INDESIT company

Model type:
ARMXL129IT

Commercial code:
F051097

1140350B Exploded views

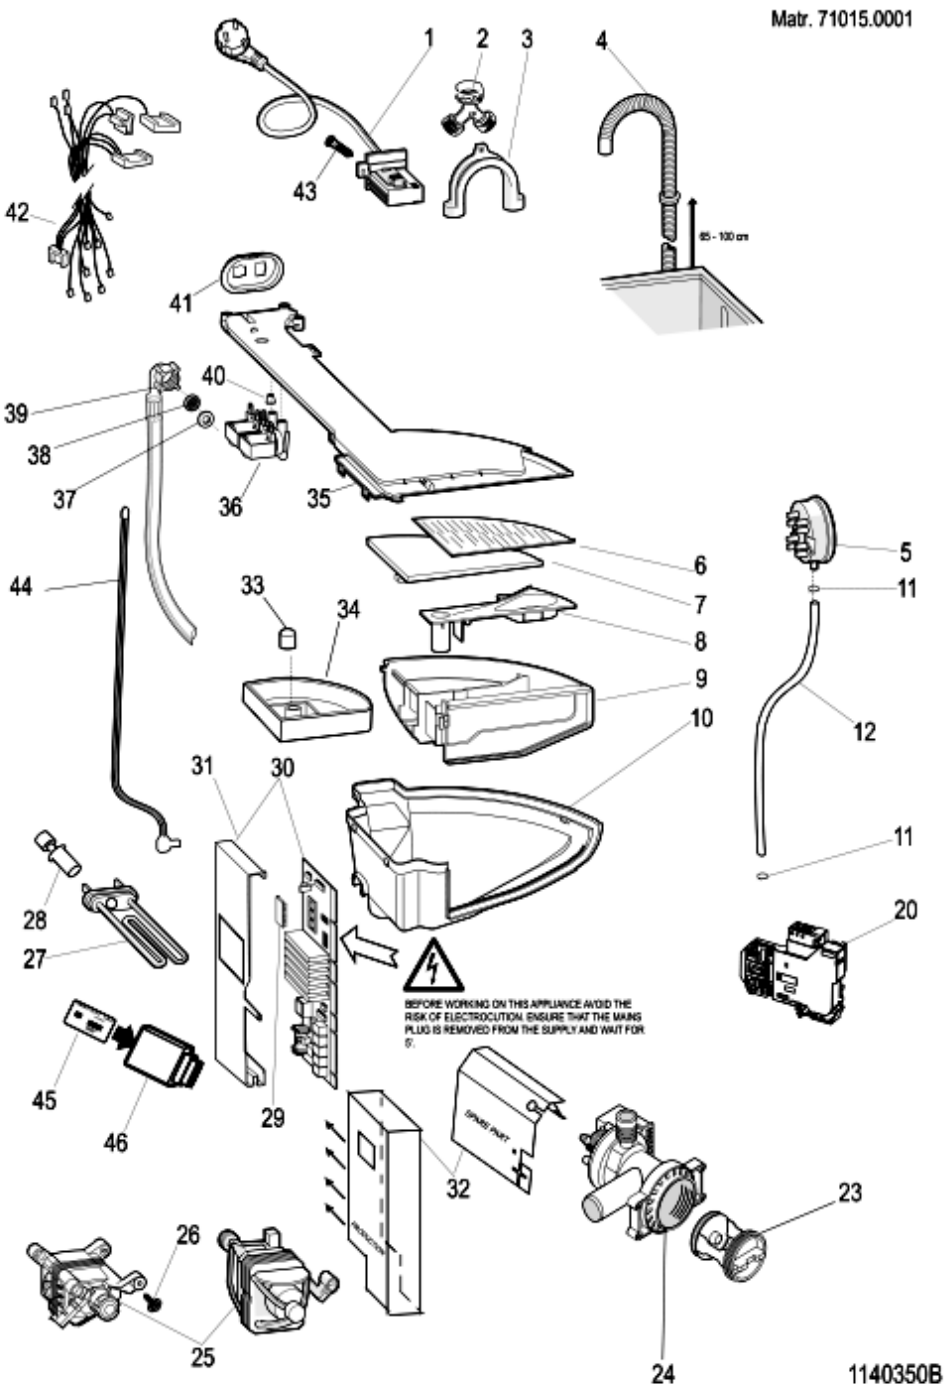
n4008f00: Thermic link wire removed on three-phase motor

When you assist the premodification models using the new motor code you MUST use the thermic link wire code C00265838.

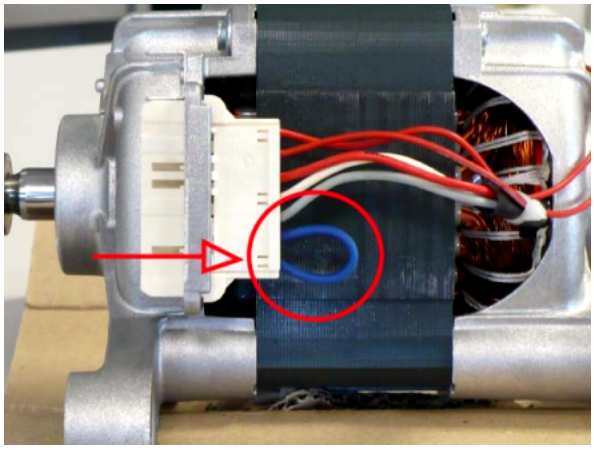
Attention!

The spare part warehouses will manage the premodification motor until the end of the stock, after they will be replaced with new ones and thermic link wire.

TRIPHASE P40 46 L – INOX TUB
C00265827 new motor without thermic link wire - C00116103 premodification motor with thermic link wire

TRIPHASE P40 46 L – PLASTIC TUB
C00265826 new motor without thermic link wire - C00142390 premodification motor with thermic link wire

TRIPHASE P50 52 L
C00265829 new motor without thermic link wire - C00142205 premodification motor with thermic link wire

TRIPHASE P32 46 L TOP LOADING
C00265832 new motor without thermic link wire - C00262375 premodification motor with thermic link wire

TRIPHASE P40 46 L TOP LOADING
C00265834 nuovo new motor without thermic link wire - C00112739 premodification motor with thermic link wire

In the attached image you can see the fixing of thermic link wire in the motor therminal box.
